Access Compliance Report

Public Rights-of-Way

(Curb Ramps)

Intersection ID: 12570	Main Street: HARRISBURG_RD	Cross Street: STARNES_RANDALL_RD	Location: W
ADA ID: F5012D6E2971	Ramp Type: Perp	Initial Pass/Fail: Fail	Overall Compliance: No
Severity Score: 10			
Codes/Mitigation Info/Possible Solution		Field Measurements/Component Compliance

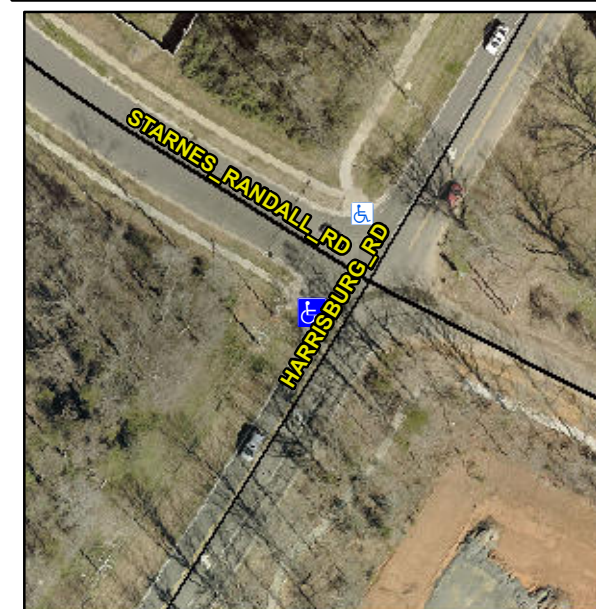
Not Found, R304.5.1, R304.5.3

Compliance	Description	Data	Compliance	Description	Data
N/A	Ramp Length (in)	83.5	Yes	Ramp Slope (%)	5.2
No	Ramp Width (in)	45.5	No	Ramp XSlope (%)	2.1
N/A	Flare Type LT	N/A	N/A	Flare Type RT	N/A
N/A	Flare Slope LT (%)	N/A	N/A	Flare Slope RT (%)	N/A
N/A	Flare Traversable LT?	N/A	N/A	Flare Traversable RT?	N/A
N/A	Landing Length (in)	N/A	N/A	DWS Provided?	N/A
N/A	Landing Width (in)	N/A	N/A	DWS Contrast?	N/A
N/A	Landing Slope (%)	N/A	N/A	DWS Length (in)	N/A
N/A	Landing X Slope (%)	N/A	N/A	DWS Full Width?	N/A
N/A	Landing Curb? (Y/N)	N/A	N/A	DWS Offset (in)	N/A
N/A	Shared Landing?	N/A			
N/A	Gutter Ponding?	N/A	N/A	Gutter Slope (%)	N/A
N/A	Gutter Lip Ht (in)	N/A	N/A	Gutter X Slope (%)	N/A
N/A	Painted X Walk1?	No	N/A	Painted X Walk2?	N/A
	X Walk 1 Direction	To NE		X Walk 2 Direction	N/A
N/A	X Walk 1 Width (in)	N/A	N/A	X Walk 2 Width (in)	N/A
	X Walk 1 Slope (%)	2.3		X Walk 2 Slope (%)	N/A
	X Walk 1 X Slope (%)	2.7		X Walk 2 X Slope (%)	N/A

Remove & Replace Entire Ramp.
